PCN# 20160412001
Qualification of AIZU as an additional Wafer Fab Site option for select devices
Change Notification / Sample Request

PCN Number:	20160421001		PCN Date:	4/27/2016
Title:	Qualification of AIZU as an additional Wafer Fab Site option for select devices in F05 and HPA07 Technology			
Customer Contact:	PCN Manager		Dept:	Quality Services
Proposed 1st Ship Date:	7/27/2016	Estimated Sample Availability:	Date provided at sample request.	
Change Type:				
<input type="checkbox"/> Assembly Site	<input type="checkbox"/> Assembly Process	<input type="checkbox"/> Assembly Materials		
<input type="checkbox"/> Design	<input type="checkbox"/> Electrical Specification	<input type="checkbox"/> Mechanical Specification		
<input type="checkbox"/> Test Site	<input type="checkbox"/> Packing/Shipping/Labeling	<input type="checkbox"/> Test Process		
<input type="checkbox"/> Wafer Bump Site	<input type="checkbox"/> Wafer Bump Material	<input type="checkbox"/> Wafer Bump Process		
<input checked="" type="checkbox"/> Wafer Fab Site	<input type="checkbox"/> Wafer Fab Materials	<input type="checkbox"/> Wafer Fab Process

Sample product shipping label (not actual product label)

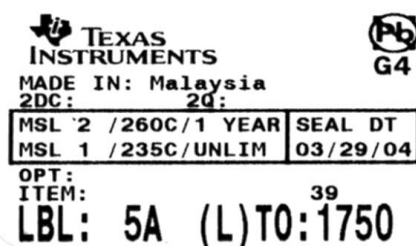
Changes to product identification resulting from this PCN:

Current

Chip Site	Chip Site Origin (20L)	Chip Site Country Code (21L)	Chip Site City
DP1DM5	DM5	USA	Richardson

New Fab Site

Chip Site	Chip Site Origin (20L)	Chip Site Country Code (21L)	Chip Site City
AIZU	CU2	JPN	Aizuwakamatsu-shi
